City of Burlingame

Meeting Minutes Planning Commission

Monday, January 25, 2016

- a. 556 El Camino Real, zoned R-3 - Application for Environmental Scoping for Environmental Review, Condominium Permit, Design Review, and Conditional Use Permit for building height for a new five-story, 21-unit residential condominium with below-grade parking (VMK Design Group, designer; Roman Knop, property owner) (462 noticed) Staff Contact: Kevin Gardiner

SCALE: NUMBER
 SHEET: NUMBER
A3
 OF: DATE
 FILE: R021050

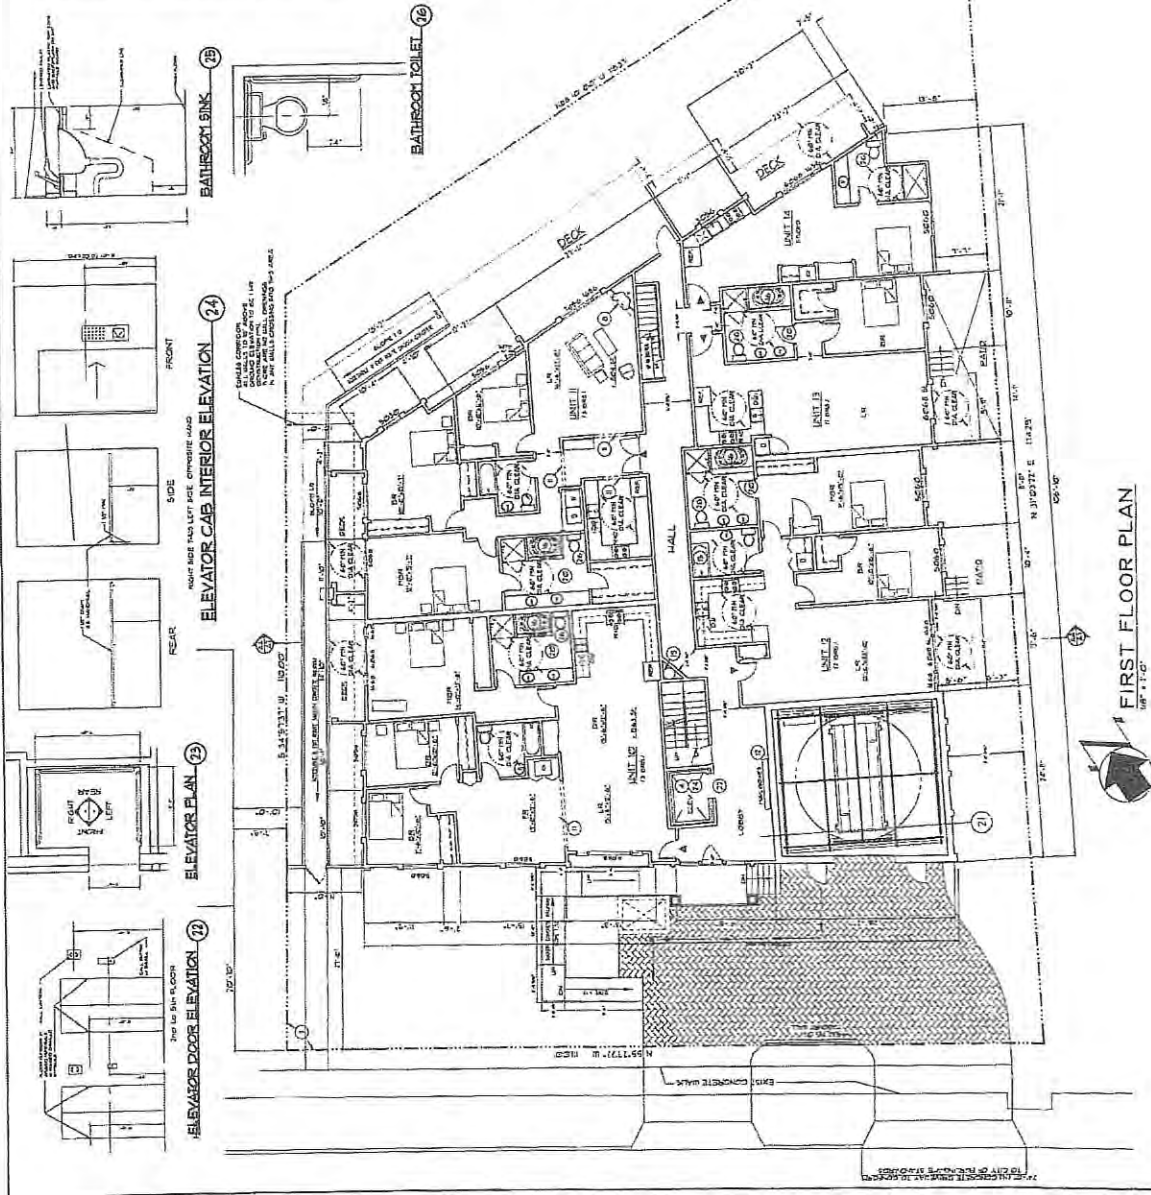
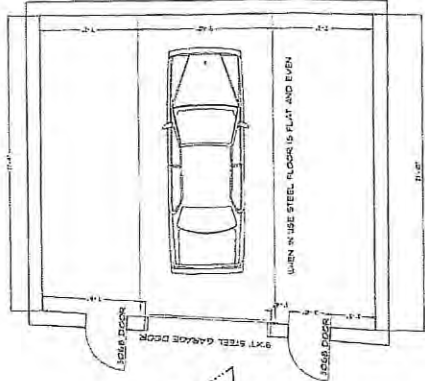
- > Is a requirement for one service vehicle space; where is it? Can residents get past a truck parked in the driveway? Concerned that the traffic flow into the garage will be blocked. (Malik-Karamov - referenced sheet A2 of the plans. Showed the drop off area for handicapped. The truck can be parked in the driveway used by residents' cars; residents will be able to drive around the truck. Can be scheduled for specific times.)

- > The rendering of the plan should show all details of what will be on the roof of the structure (venting, etc.)
- > On page A2, the first unit at the top left corner; what does LD mean? (Malik-Karamov - laundry. There will be two laundry rooms. One for the master bedroom, the other for the other bedrooms.) Has never seen this type of arrangement before. Another unit has the laundry facility in the closet in the master bedroom. Wants to be certain that the floor plans are understandable.
